STAFF RECOMMENDATION

NCPC File No. 6528

**WALTER REED ARMY MEDICAL CENTER, MAIN SECTION
RENOVATION OF AND ADDITION TO BUILDING 40
14th and Dahlia Streets, NW
Washington, DC**

October 28, 2004

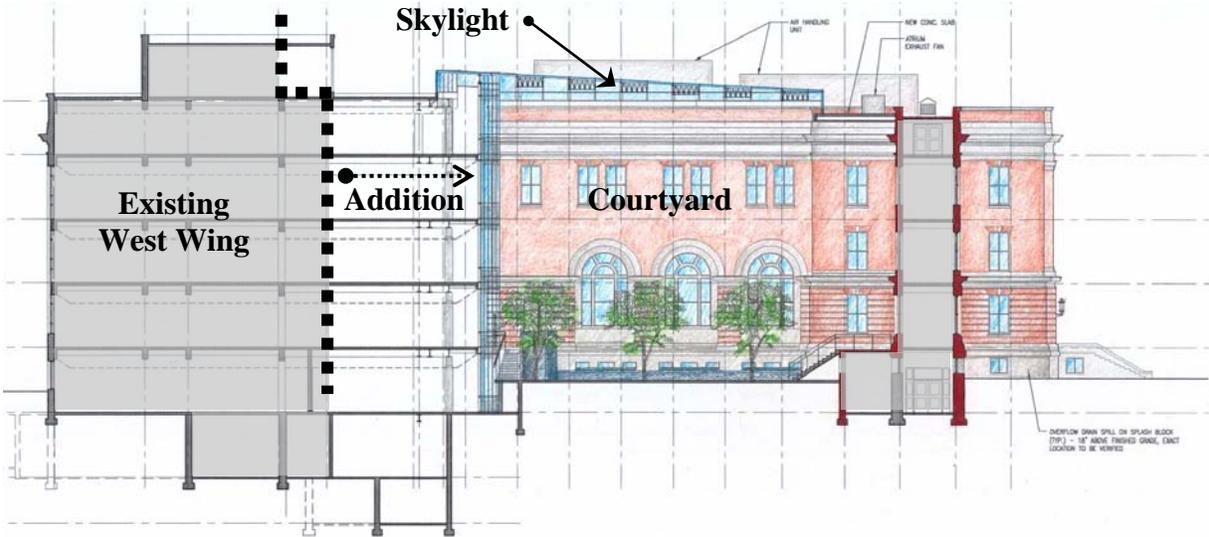
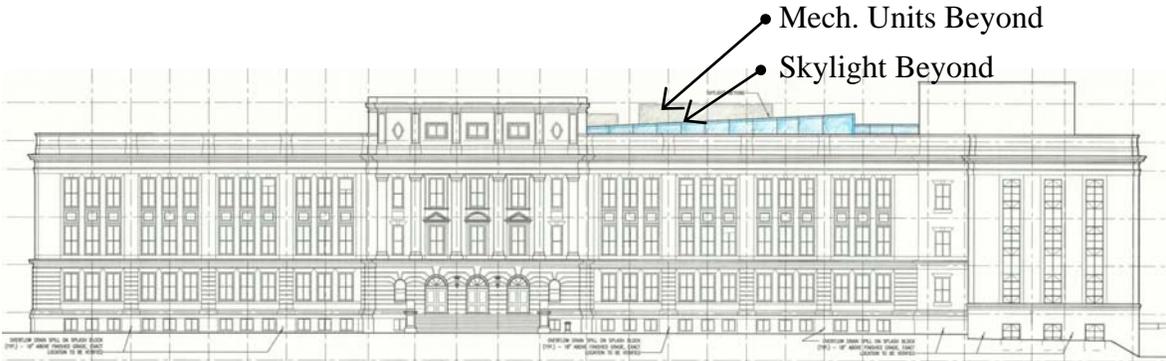
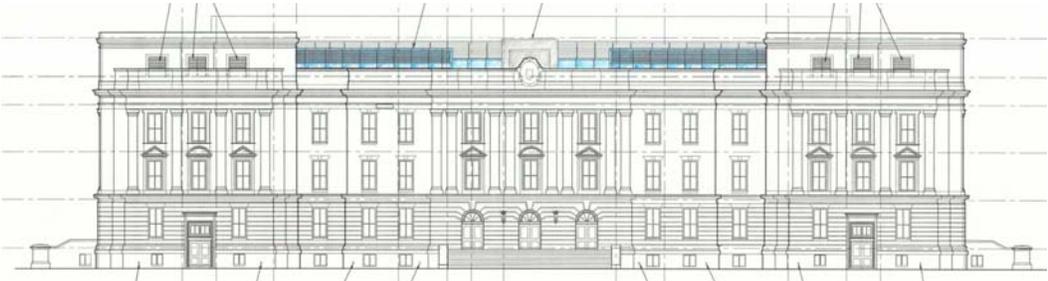
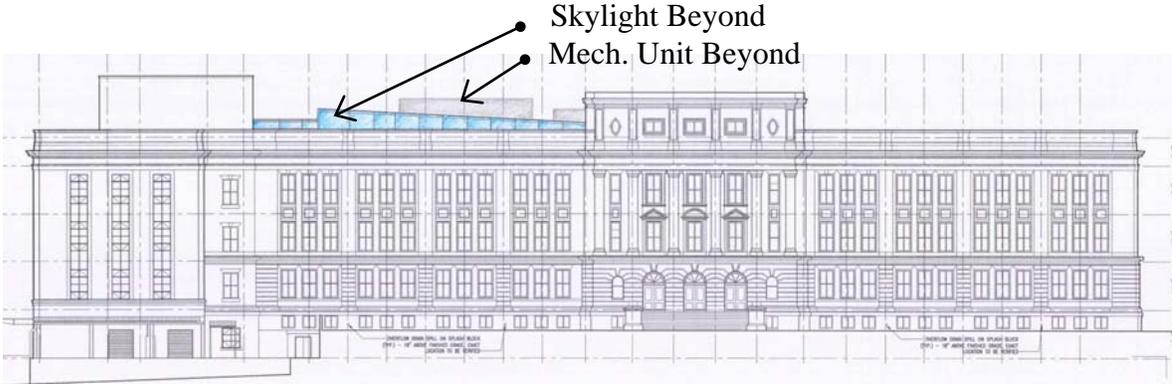
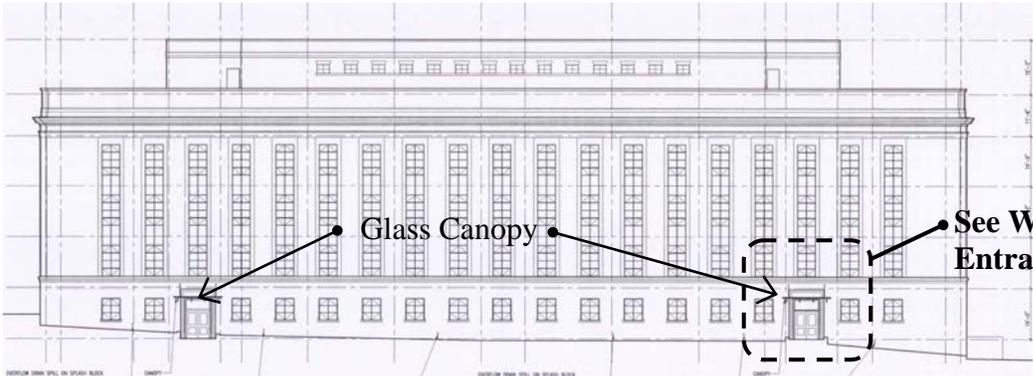
Staff notes that the courtyard building addition, west wing penthouse addition, and courtyard skylight, for the most part, will have minimal impact to the exterior of the building. The courtyard addition and west wing penthouse will be visible from within the courtyard. The highest point of the sloping skylight may be somewhat visible from the north and south along 14th Street, however it will not be seen from the east or west. Staff notes that the low profile skylight will provide ample daylight to interior spaces surrounding the courtyard. Staff commends the incorporation of the skylight over the courtyard which will create a dynamic interior space and improve the quality of life for building tenants. The small, glass canopies over the west wing entrances will be compatible with the existing 1960's facade.
